Martin County Solar Project, LLC
Response to Siting Board's Second Request for Information
Case No. 2021-00029

MARTIN COUNTY SOLAR PROJECT

Client/Project
 Martin County Solar LLC
 Martin County Solar Facility
 Noise Assessment

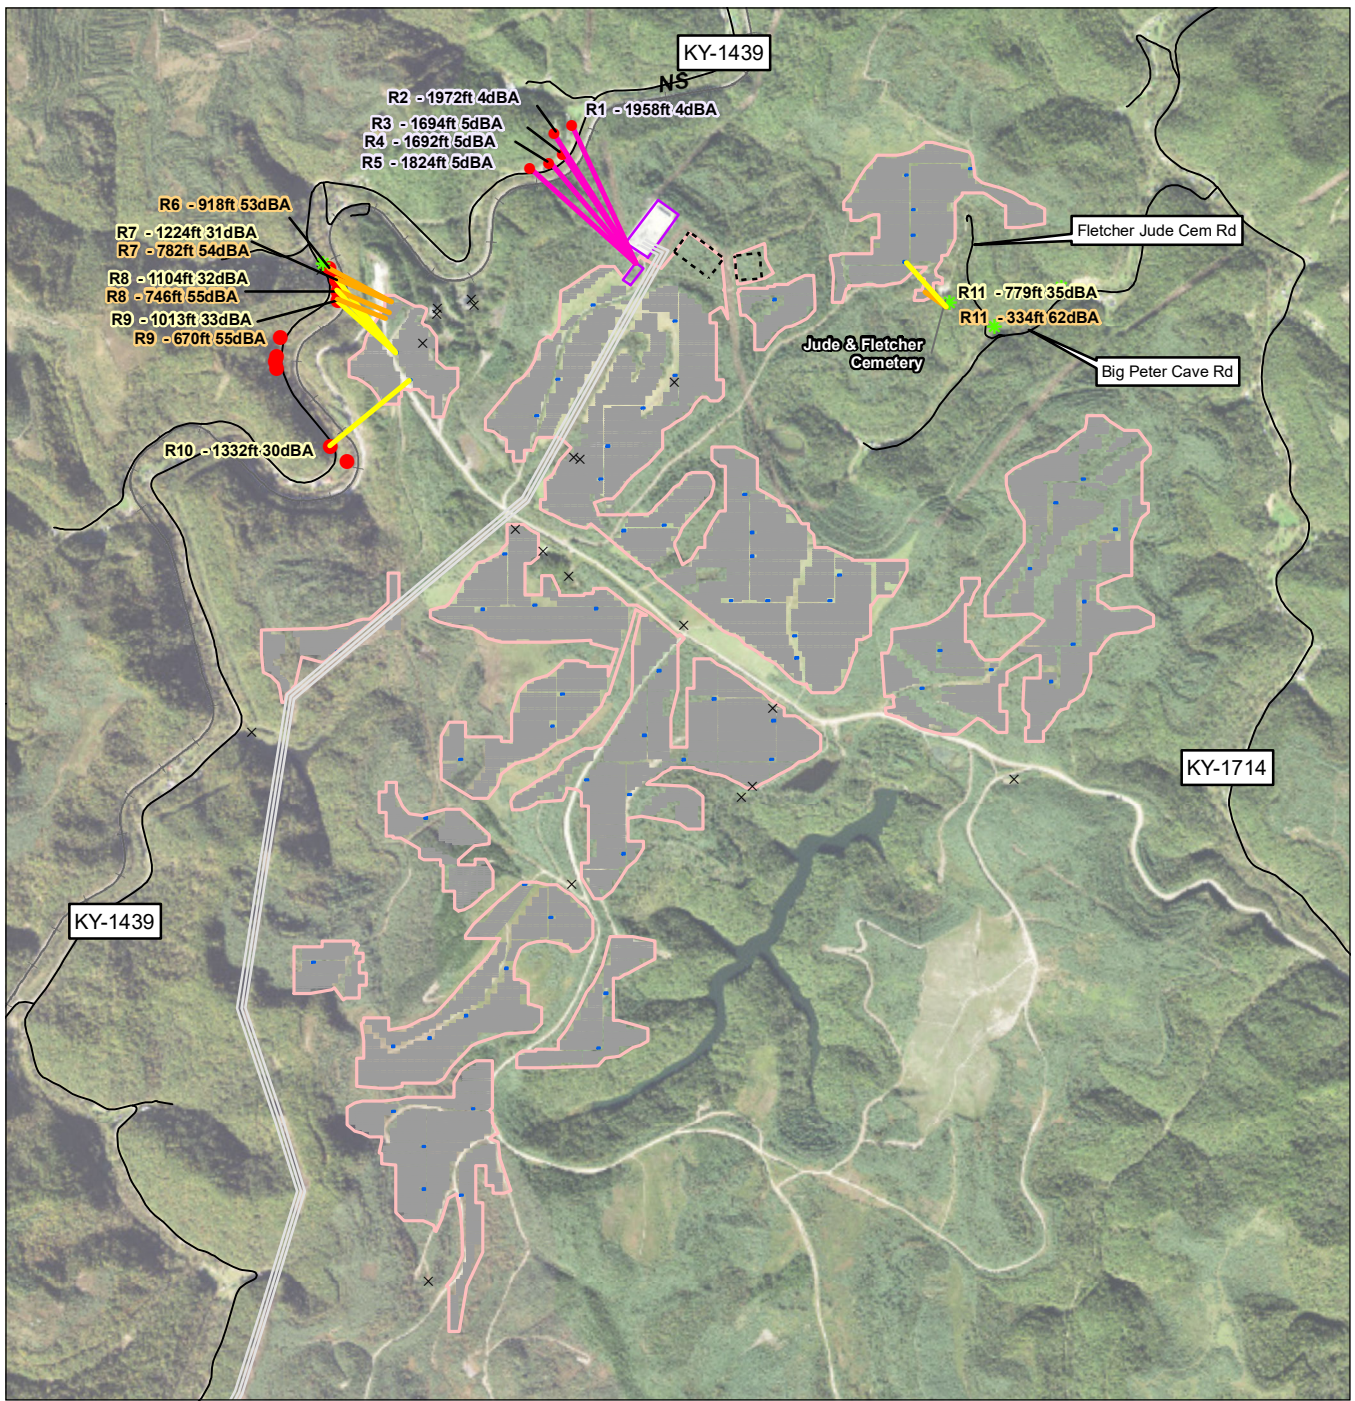
Request No. 2: Refer to page 2 of the Site Assessment Report (SAR), Exhibit F, which indicates there will be an operation and maintenance trailer on site. Confirm the approximate location of this trailer and file a PDF map showing its location

Response: See below.
